Nose Fork Fatigue Cracks

EFFECTIVITY**MODEL-** Ranger R7**SERIAL NO:** ALL AIRCRAFT WITH THE 810601 NOSE FORK (10131-10186)**REASON**

Figure 1

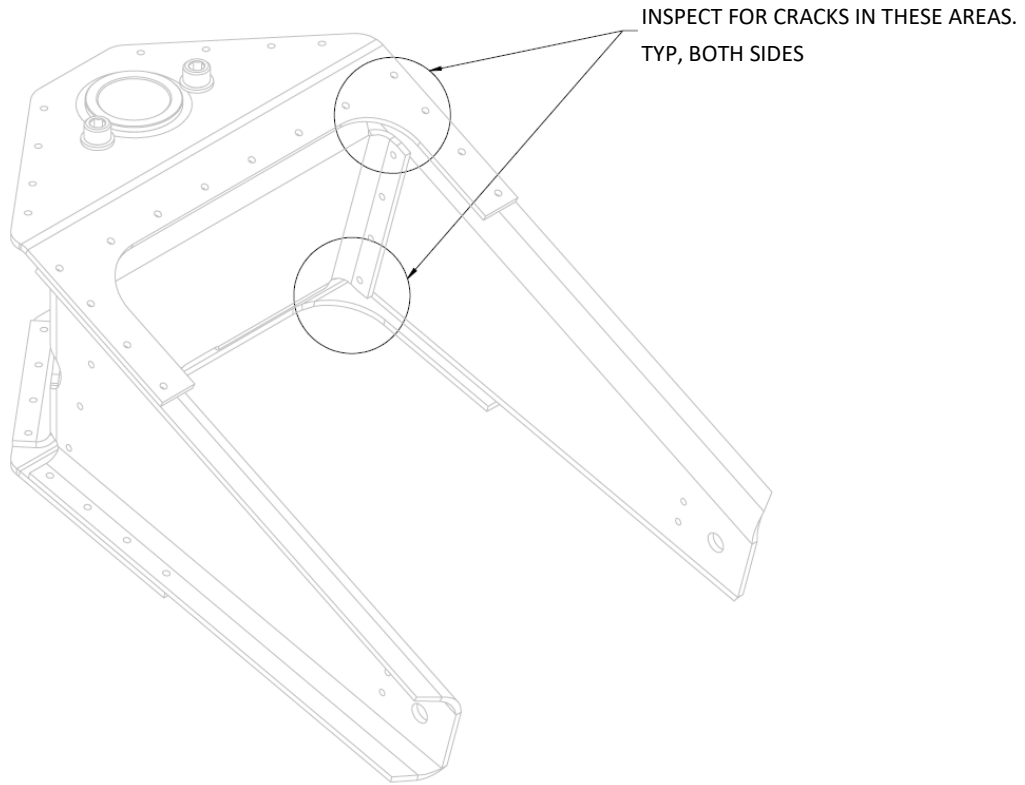
Inspect nose fork for cracks in the areas shown in Figure 1 and Figure 2. If any cracks are present, DO NOT continue flying—Contact Vashon Aircraft for corrective action until a subsequent bulletin is released.

INSPECT FOR CRACKS IN THESE AREAS.
TYP, BOTH SIDES
